Subdivision Authority

File No. LDA10-0010

RE: Tentative plan of subdivision to create thirty-five single detached residential lots, one (1) environmental reserve lot, two (2) municipal reserve lots and four (4) public utility lots from a portion of Lot D, Block X, Plan 052 6241, located north and west of Cameron Heights Drive, **CAMERON HEIGHTS**

SUBDIVISION CONDITIONS OF APPROVAL MAP

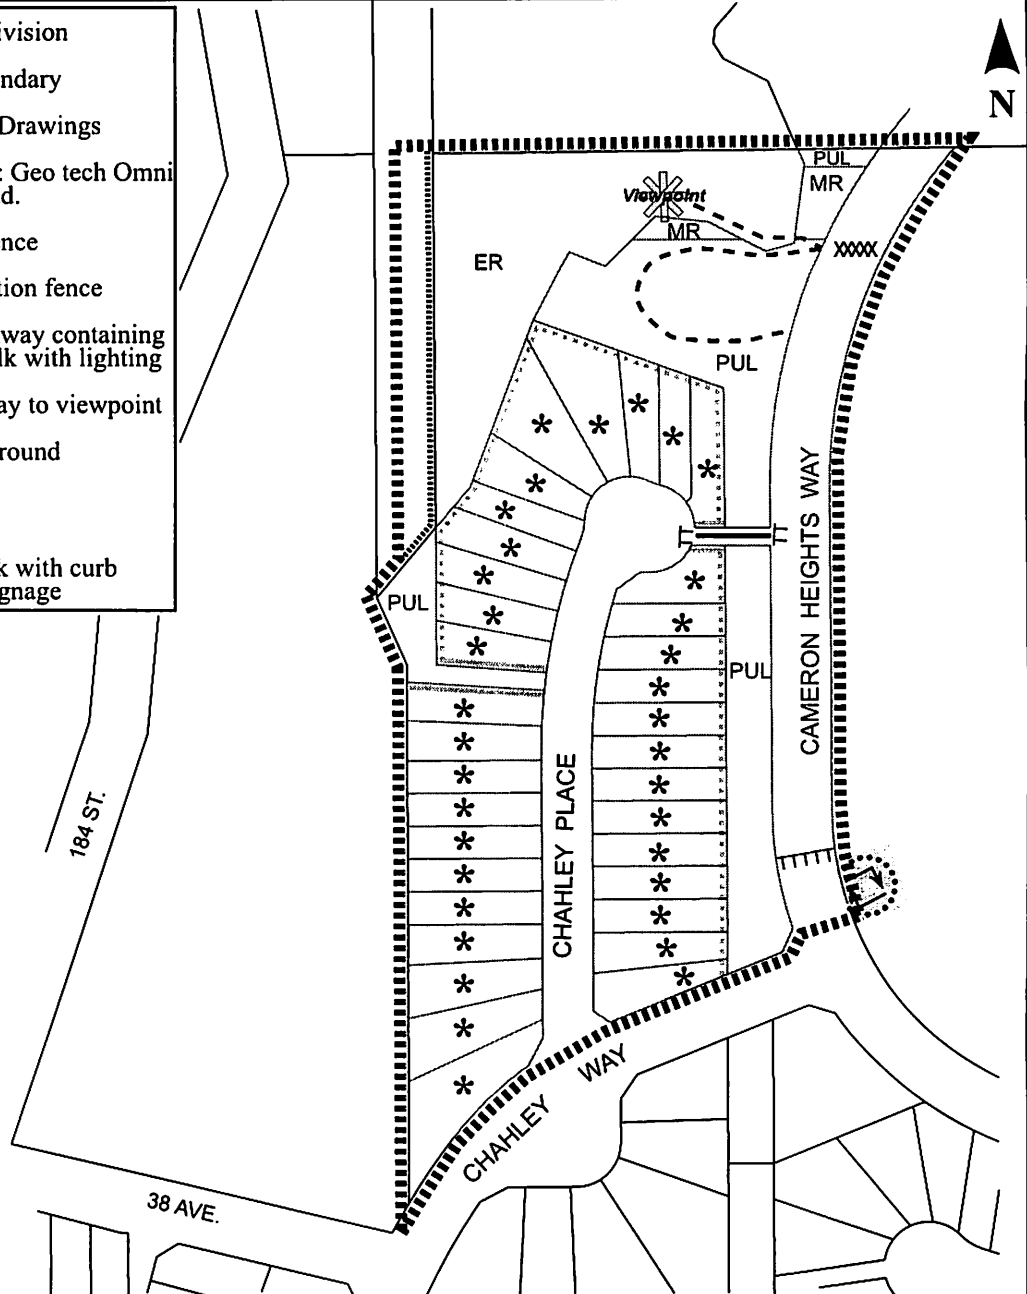
1. that the owner dedicate Municipal Reserve as two parcels, a 0.02 ha parcel and a 0.03 ha parcel pursuant to Section 666 of the Municipal Government Act as shown on the attached "Conditions of Approval" map, Enclosure I;

5. that the subdivision boundary be amended to exclude the road right of way along the west side of the site, as shown on the "Conditions of Approval" map, Enclosure I;

6. that the owner register an emergency access walkway from Chahley Place to Cameron Heights Way, as shown on the "Conditions of Approval" map, Enclosure I; and

7. that the owner construct an emergency access containing a 3 m concrete sidewalk with T-bollards and lighting, as shown on the "Conditions of Approval" map, Enclosure 1;

8. that the owner construct a pedestrian walkway to the viewpoint, as shown on the "Conditions of Approval" map, Enclosure 1;
9. that the owner construct bollards to the satisfaction of the Transportation Department in the location as shown on the "Conditions of Approval" map, Enclosure I;

10. that the engineering drawings include the construction an offset 17 m radius asphalt surface temporary transit turnaround with bollards or mini-barriers to the satisfaction of the Transportation Department in the locations as shown on the "Conditions of Approval" map, Enclosure I;

11. that with the extension of Cameron Heights Way north of this subdivision, the owner must remove the 17 m temporary transit turnaround, located north of the intersection of Chahley Way and Cameron Heights Way, as shown in the "Conditions of Approval Map", Enclosure I. The transit turnaround must be removed, all temporary fencing removed, sidewalk, curb and gutter constructed and boulevard restored, to the satisfaction of the Transportation Department and Parks Branch of Asset Management Public Works;

13. that the owner provide a zebra-marked crosswalk with curb ramps and pedestrian signage at the mid-block crossing, as shown on the "Conditions of Approval" map, Enclosure I;

14. that the owner construct all fences positioned wholly on privately owned land as shown on the "Conditions of Approval" map, Enclosure I; and
15. that the owner is responsible for the design, landscaping and construction within the public utility lots, utility right-of-way, road islands, boulevards, medians, walkways and Municipal Reserve parcels, to the satisfaction of the Community Services, Transportation and Asset Management and Public Works Departments.
